Business Unit: HARTING Electric
Product range: Han-Modular®
Author: Han® E Protected Module

PCN/ 011
Date: 2013-11-04
Page 1/2

Please be informed about design change implemented in the female Han® E Protected Module (p/n: 09 14 006 3141). Please see below images detailing this change.

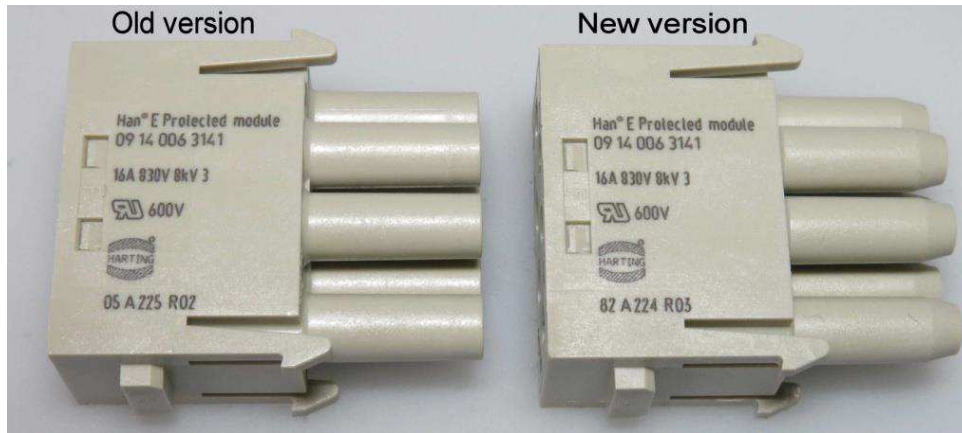
- New design has a lead-in chamfer that avoids interferences with the male module
- All mechanical and electrical characteristics remained the same compared to the old design. The module is 100% mating compatible.
- The part number remained the same; however, the revision number has changed from 02 to 03.
